## Attachment J – Cultural Resources: Impacts Assessment and Correspondence

- Virginia Department of Historic Resources letter dated October 31, 2022
- Impacts Assessment and Avoidance of NRHP-Eligible Resources

RE: Waller Solar Project  
Lancaster County, Virginia  
DHR File No. 2021-0216

RE: *Phase I Cultural Resources Survey of the Waller Solar Project in Lancaster County, Virginia*  
Impacts Assessment and Avoidance of NRHP-Eligible Resources  
DHR File No. 2021-0216

Figure 1: Waller Solar Project conceptual site plan, showing planned avoidance of Site 44LA0184.

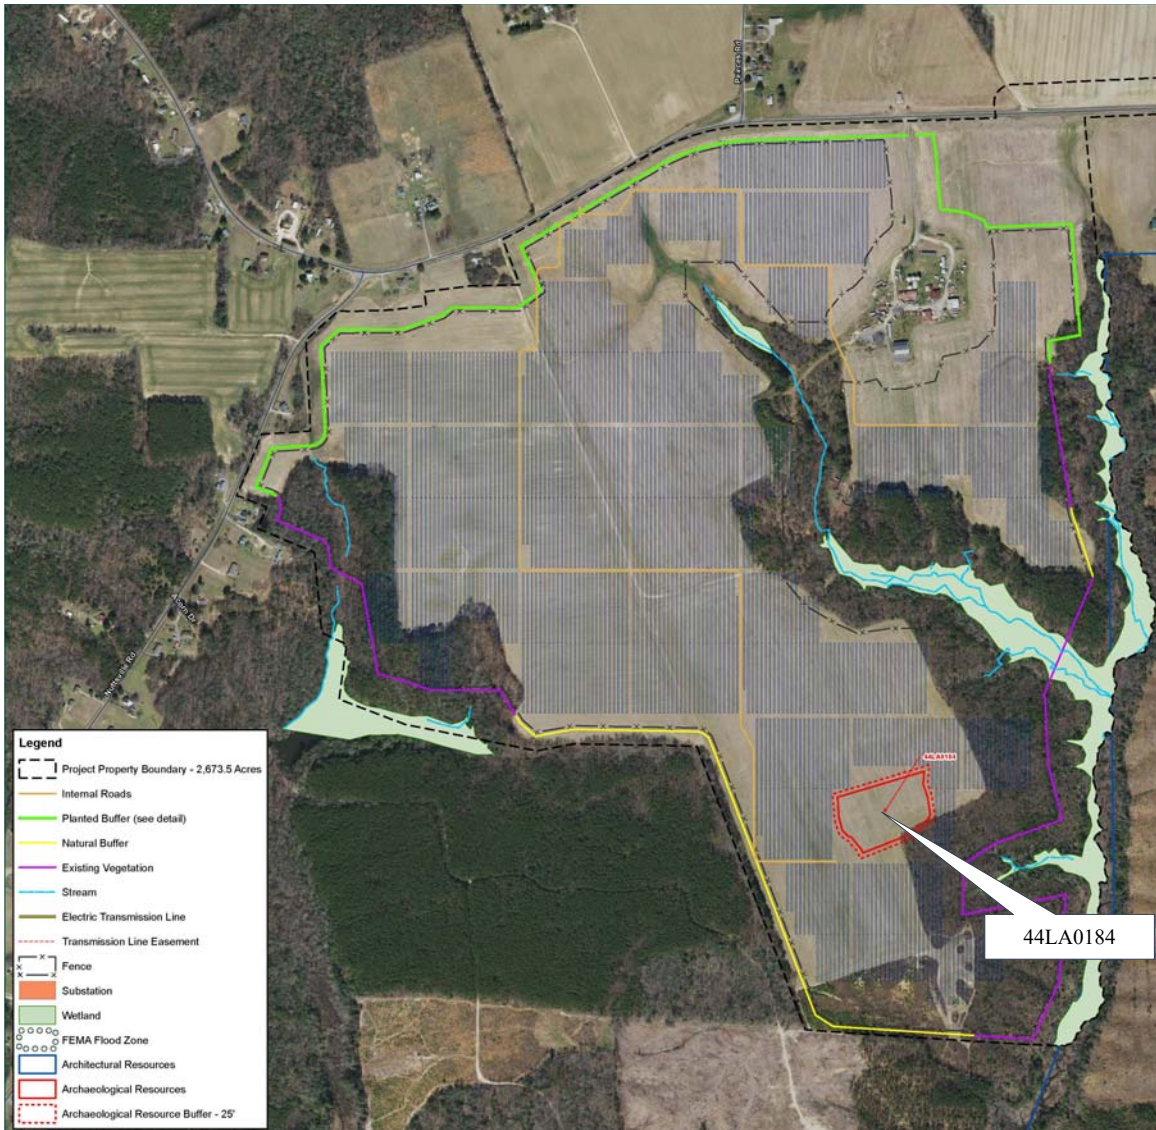
Sites **44LA0184** and **44LA0185** were both recommended as *potentially eligible* for listing in the National Register of Historic Places (NRHP). D+A recommended that both sites be avoided or conduct additional investigations if impacts could not be avoided. In a letter dated July 22, 2022, DHR concurred with D+A's recommendations. D+A conducted Phase II investigations at 44LA0184 and recommended the site as eligible for listing in the NRHP. DHR required additional info to evaluate the horizontal boundaries of 44LA0184. As such the site is considered *potentially eligible* (correspondence dated Oct. 6, 2022). Both sites (44LA0184 and 44LA0185) will be avoided with a 25-foot buffer. As a result, the project will not adversely impact any NRHP-eligible archaeological sites. DHR concurs with the proposed avoidance buffer of 25 feet. Please be sure to provide a detailed description of the avoidance measures in the mitigation plan for the PBR application.

As part of the Phase I survey, a total of five archaeological sites were identified, two of which (44LA0184 and 44LA0185) were found to be potentially eligible for listing in the NRHP and VDHR recommended avoidance or further Phase II investigation. Subsequently, D+A conducted Phase II investigation of Site 44LA0184 which resulted in refined boundaries of the NRHP-eligible portion of the site (D+A *Phase II Archaeological Evaluation of Site 44LA0184* September 2022). As a result, Waller Solar I, LLC has employed measures to ensure avoidance of both NRHP-eligible sites, and has revised the conceptual site plan to incorporate an avoidance area around each with a 25-foot buffer in accordance with the recommendation from VDHR. Figures 1 and 2 provide detail of the avoidance area around each site, and a full-resolution conceptual site plan may be found as Attachment A.

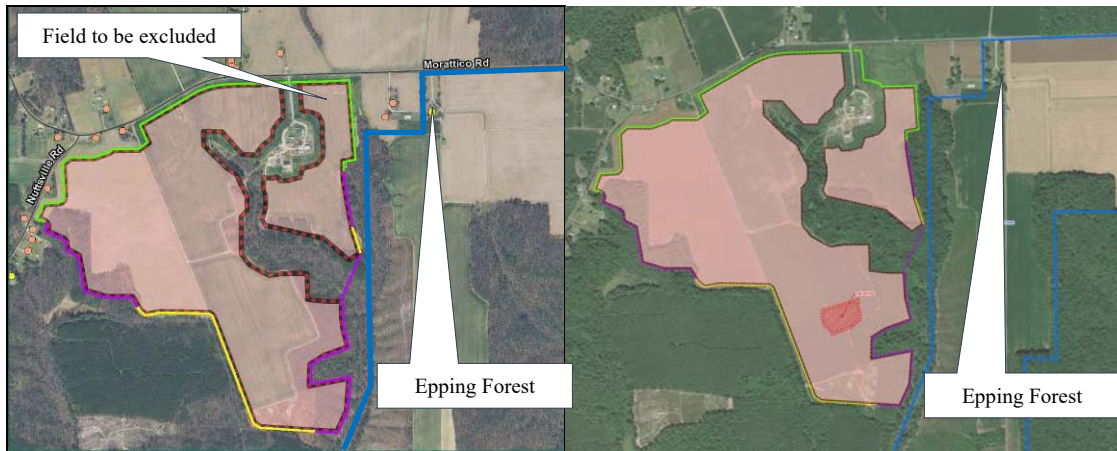
D+A recommended a moderate impact to the Virginia Landmarks Register (VLR) and National Register of Historic Places (NRHP) eligible Epping Forest (DHR ID #051-0008) and DHR concurred. As a result, Waller Solar I, LLC has undertaken measures to minimize the visual impact to Epping Forest through modifications to the conceptual site plan, providing a detailed planting plan and producing renderings for the property. With the revised array layout and landscape plan, D+A recommends that the project will pose no more than a minimal impact to Epping Forest and DHR *concur*s with the condition that the planting plan is planted as shown in current plans or DHR coordination is reopened, that photos are provided of the planting buffer once installed, and any plants that do not take in the first year be replaced in kind and installed by the project proponent

As part of the Phase I survey and initial viewshed analysis, VDHR determined that the project would have a *moderate impact* on the resource. At that time, project improvements were proposed within a field to the west of the Epping Forest property, immediately adjacent to a parcel bordering it, roughly 0.21 mile. To minimize visibility of the project and overall impact, Waller Solar I, LLC has reengineered the project in this vicinity to avoid the utilization of the field nearest to Epping Forest, and has set all improvements back an additional roughly 1,000 feet. As such, the nearest potentially visible improvements will be setback on the far side of a farm lane, roughly 0.37 mile from the Epping Forest House. The proposed landscaping plan was also revised accordingly to shift the supplemental plantings with the array setback. As a result, not only will the project improvements be further away from Epping Forest, but the planting buffer will be more effective due to the topography of the project area. Where initially proposed the buffer extended along the base of a shallow depression on the edge of the project area parcel and therefore would have been below the siteline from Epping Forest above, whereas in the new arrangement the planted buffer will extend along the high point of the landscape and therefore more effectively and quickly screen improvements as the plantings mature. The rest of the project improvements and solar arrays will continue to be screened by robust existing vegetation bordering the property.

With the revised array layout and landscape plan, it is recommended that the project will pose no more than a *minimal impact* to Epping Forest. In support of this recommendation and to provide the requested additional data, Figure 3 provides a comparison of the preliminary and revised conceptual site layout with landscape plan. Figure 4 provided a detailed conceptual site plan for the vicinity of the property. Figure 5

**Figure 14: Waller Solar Conceptual Project Site Plan in relation to Edgely depicting the extent of project improvements and landscape buffer. Edgely resource boundary depicted in blue with location of primary dwelling flagged with callout. Source: Timmons Group**

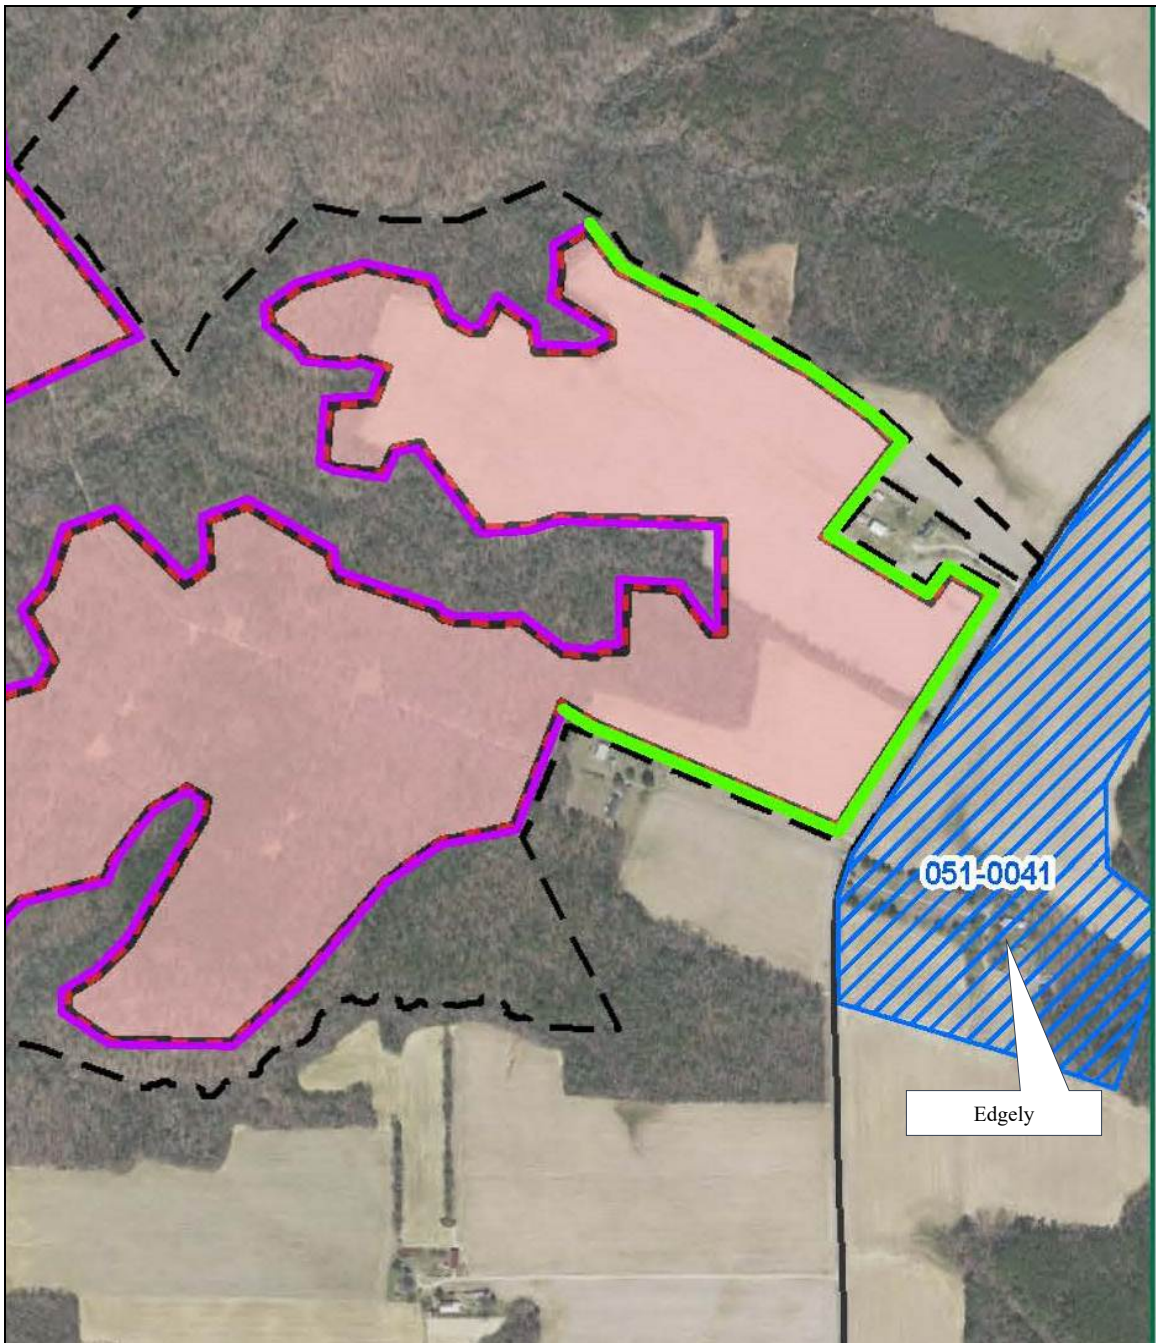
Thank you for providing additional information on impacts to historic architectural resources. Dutton + Associated (D+A) initially recommended a minimal impact for three (3) resources: Edgely (DHR ID #051-0041), Lebanon Baptist Church (DHR ID #051-0059) and Lively School (DHR ID #051-0096); and DHR concurred that there will be a minimal impact to DHR ID #s 051-0041, 051-0059, and 051-0096 with the condition that planting plans be submitted to DHR for review and comment with renderings showing mature

growth superimposed into the viewsheds that currently have no buffer. The requested information was submitted and we acknowledge the submission. DHR *concur*s that there will be a minimal impact to DHR ID #s 051-0041, 051-0059, and 051-0096. Provide DHR photos of the planting buffer once installed.

With this array layout and landscape plan, it is reaffirmed that the project will pose no more than a *minimal impact* to Edgely. In support of this finding and to provide the requested additional data, Figure 14 provides a conceptual site layout with landscape plan. Figure 15 provides a detailed conceptual site plan for the vicinity of the property. Figure 16 provides a detailed planting plan for the proposed landscape buffer. Figures 17 through 20 provides rendering series including a map of the location of rendering position, a photograph of existing conditions, project improvements with supplemental landscaping at the time of planting, and improvements with landscaping at maturity.
